To:	Rick Corsi Project Manager	Date:	July 23, 2019
From:	Hannah Brockhaus Howard Stein Hudson	HSH Project No.:	2018214.00
Subject:	DCR Memorial Drive Greenway Improvements, Phase III Public Meeting Meeting Notes of June 25, 2019

On June 25, members of the Department of Conservation and Recreation (DCR) Memorial Drive Greenway Improvements Phase III project team and DCR staff associated with the job held the project's second public meeting. Through this project, the agency seeks to complete the improvement of the greenway along Memorial Drive from the Boston University (B.U.) Bridge to the Eliot Bridge and analyze opportunities to reclaim riverfront parkland through lane reductions and intersections improvements, where feasible.

Alternative 2: Keep Overpass, Reconfigure At-grade Geometry

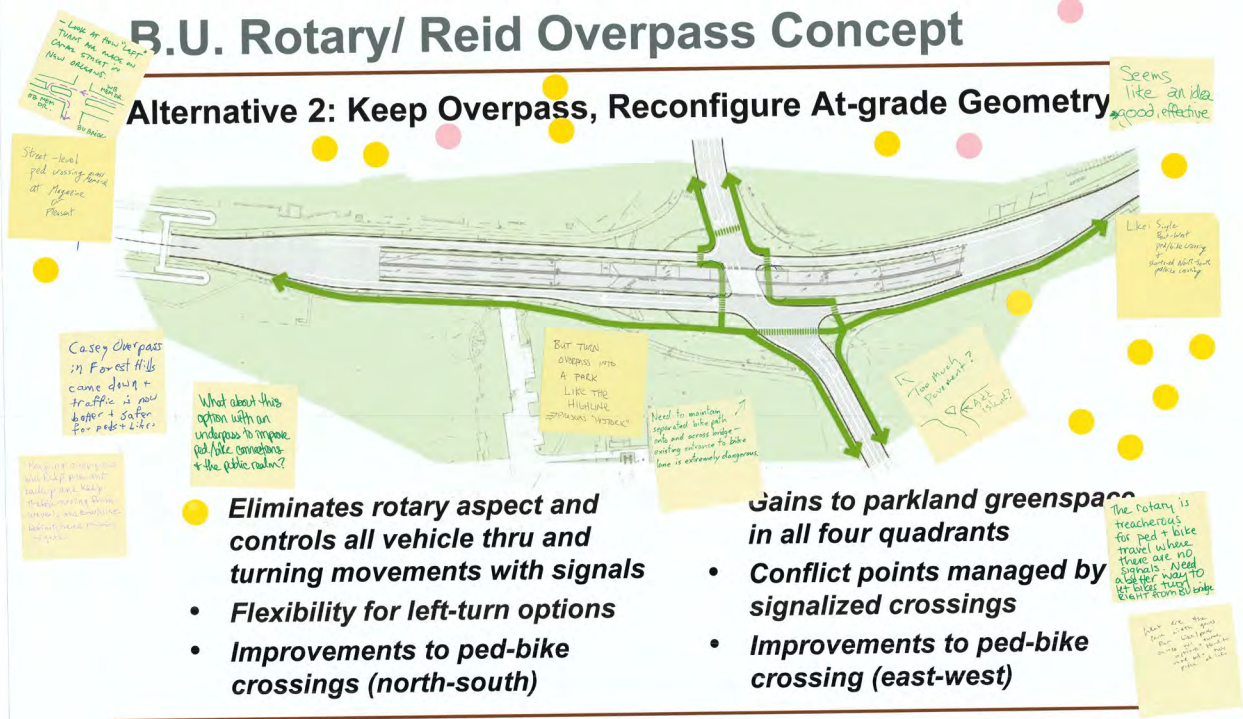
BU Rotary Concept 2: 14 attendees liked this concept while 3 did not like it. Attendees asked the project team to consider left turns similar to Canal Street in New Orleans. Others asked to consider an underpass for pedestrians and cyclists. Another comment urged the team to look at the crossings for bicycles and pedestrians. Commenters noted that keeping the overpass seems like an effective idea and will keep traffic moving while others asked to get rid of the overpass or turn it into a highline park.

Alternative 3: Remove Overpass and Accommodate Volumes At-grade

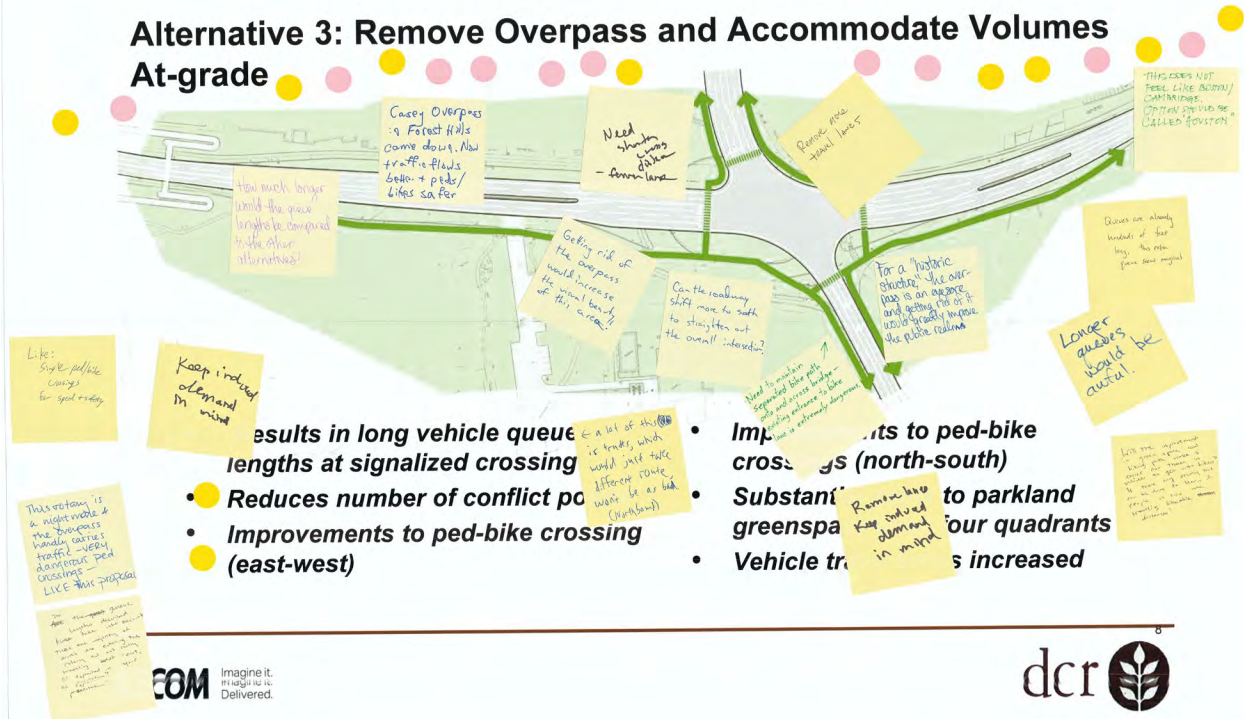
BU Rotary Concept 3. Attendees were split with 10 in favor and 10 opposed to this concept. Those in favor commented on how well the Casey Arborway functions without the overpass while others commented on how taking it down would improve the public realm and improve conditions for bicyclists and pedestrians. Others urged the team to reduce travel lanes to reduce crossing distances. Those opposed questioned how long the queues would be.

Intersection Operations – Turning Movements

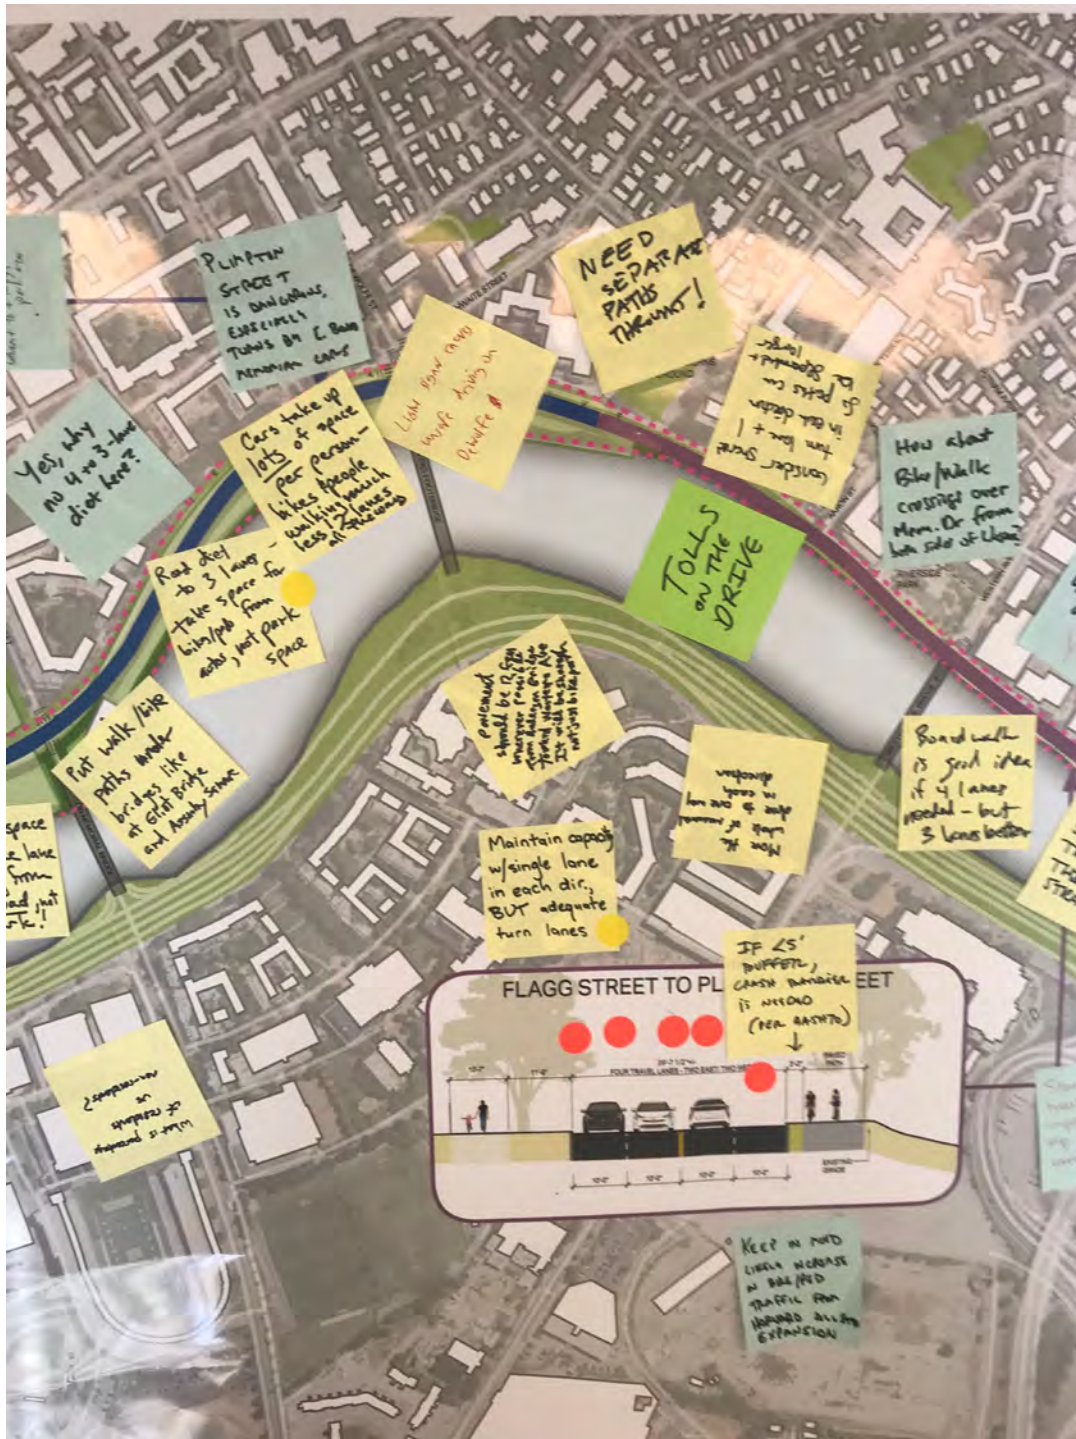
Intersection Operations-Turning Movements: Commenters noted that this map should be overlaid with conflict areas for bicycles and pedestrians. They would like a discussion on trip times for bicycles and pedestrians on the corridor and would like the project team to prioritize people, not cars and nature. A suggestion was made to only have four lanes for turning moves.

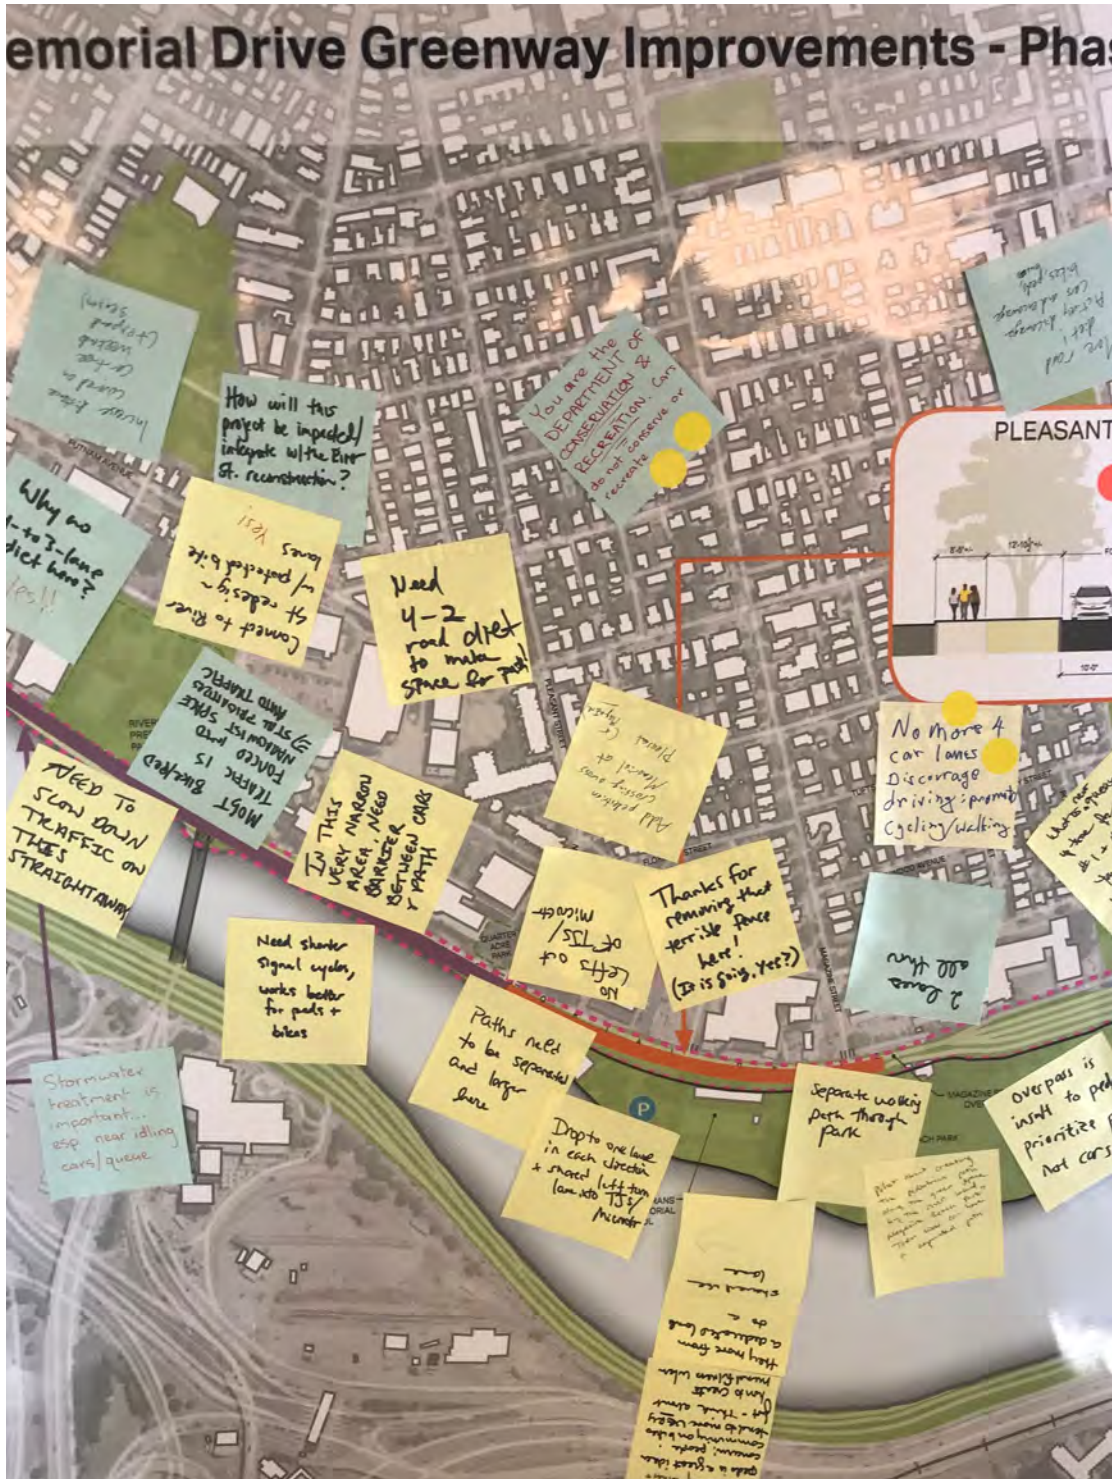
Public Comments on a section of the roll plan. Attendees would like to see a road diet, to accommodate for separated bicycle and pedestrian paths.

Memorial Drive Greenway Improvements - Phase 1

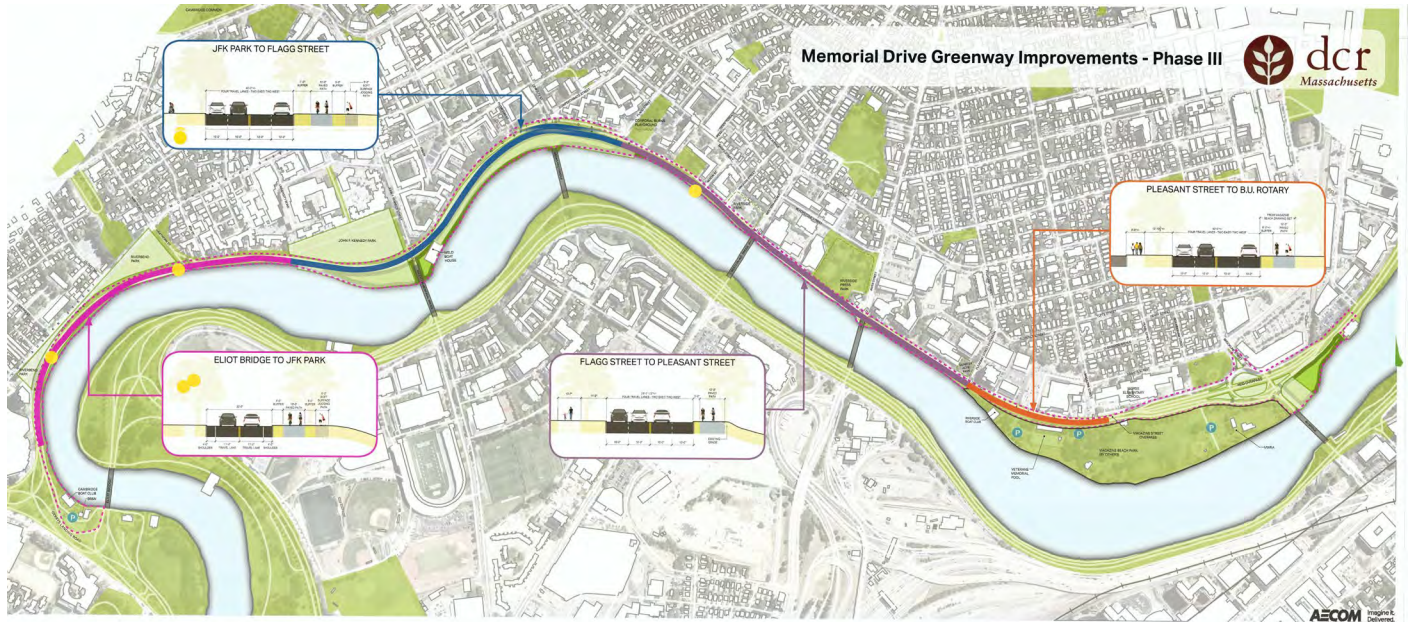
Public comments on the roll plan, attendees would like to see the lanes reduced, traffic calmed, and stormwater addressed

Western Ave and River Street Project Area

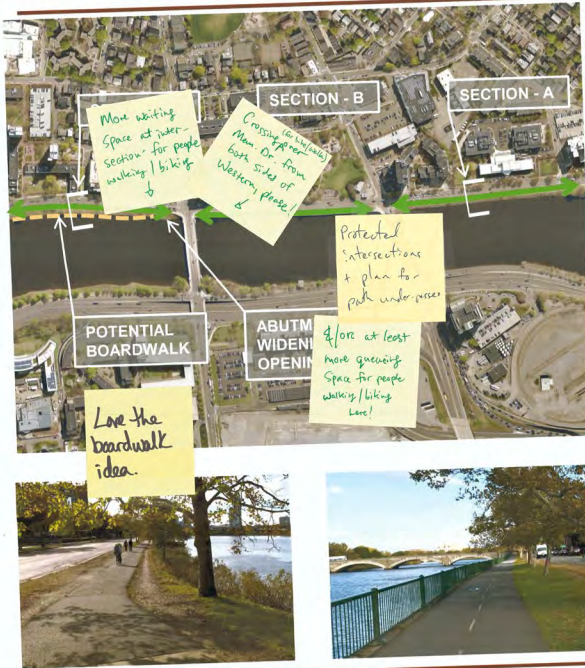
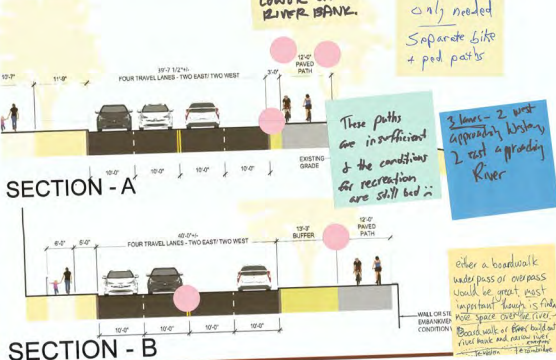
Move PATH...
10' FROM...
NORTH DR...
AND SOFT...
LOWER ON...
RIVER BANK.

2 car lanes...
only needed...
Separate bike...
& ped paths

These paths...
are insufficient...
& the conditions...
for recreation...
are still bad in

3 lanes - 2 west...
approach...
2 east...
approach...
River

either a boardwalk...
underpass or overpass...
would be great...
most important...
space...
Boardwalk...
west side of River...
road...
road...

And...
Reduce to 3 lanes...
and widen grass

Public Comments the Western Avenue and River Street project area: Users would like more queuing space and/or protected intersections for cyclists and pedestrians. Users like the idea of a boardwalk, users would like to see lanes reduced to three to allow for more green space and/or more path space as the current path space in insufficient.
